Access Compliance Report

Public Rights-of-Way

(Curb Ramps)

Intersection ID: 6087	Main Street: RUMSTONE_LN	Cross Street: WINGSTONE_LN	Location: S
ADA ID: 441EA72738AF	Ramp Type: Perp	Initial Pass/Fail: Fail	Overall Compliance: No
		Severity Score: 12.5

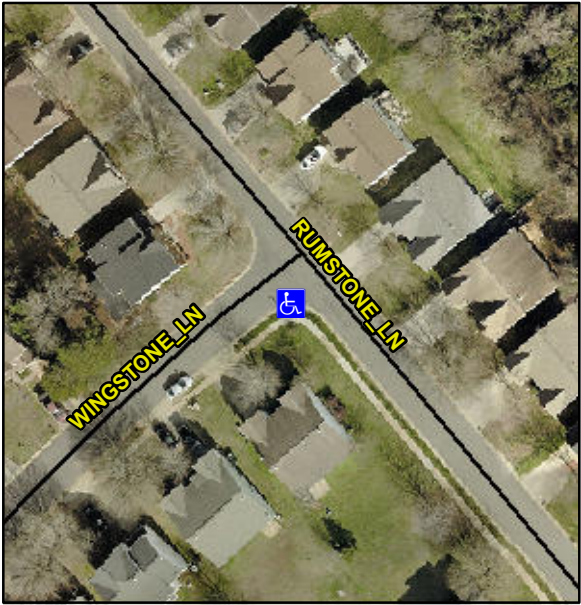
Codes/Mitigation Info/Possible Solution			Field Measurements/Component Compliance		
	Possible Solutions:		Compliance	Description	Data
	Remove & Replace Entire Ramp.		Yes	Ramp Length (in)	48.0
			N/A	Ramp Width (in)	48.0
			N/A	Flare Type LT	N/A
			N/A	Flare Slope LT (%)	N/A
			N/A	Flare Traversable LT?	N/A
			N/A	Landing Length (in)	N/A
			N/A	Landing Width (in)	N/A
			N/A	Landing Slope (%)	N/A
			N/A	Landing X Slope (%)	N/A
<p>Surveyor Notes:</p> <p>N/A</p> <p>PROW/ADA:</p> <p>Not Found, R304.5.3</p>			N/A	Flare Type RT	N/A
			N/A	Flare Slope RT (%)	N/A
			N/A	Flare Traversable RT?	N/A
			N/A	DWS Provided?	N/A
			N/A	DWS Contrast?	N/A
			N/A	DWS Length (in)	N/A
			N/A	DWS Full Width?	N/A
			N/A	DWS Offset (in)	N/A
			N/A	Shared Landing?	N/A
			N/A	Gutter Ponding?	N/A
			N/A	Gutter Lip Ht (in)	N/A
			N/A	Painted X Walk1?	No
			To N	X Walk 1 Direction	N/A
			N/A	X Walk 1 Width (in)	N/A

1.0	X Walk 1 Slope (%)	N/A
			5.0	X Walk 1 X Slope (%)	N/A
			N/A	Ramp inside XWalk1?	N/A
			N/A	Road Slope (%)	N/A
			N/A	Road X Slope (%)	N/A
			N/A	Any Obstructions?	N/A
			N/A	Obstruction Type	N/A
			N/A	Clear Space?	N/A
			N/A	Clear Space to XWalk (in)	N/A
			N/A	Storm Grate/Utility Hazard?	N/A
			N/A	Storm Grate/Utility Type	N/A
			N/A	Surface Condition? (G/P)	Good
Total Cost:		\$ 1850.00
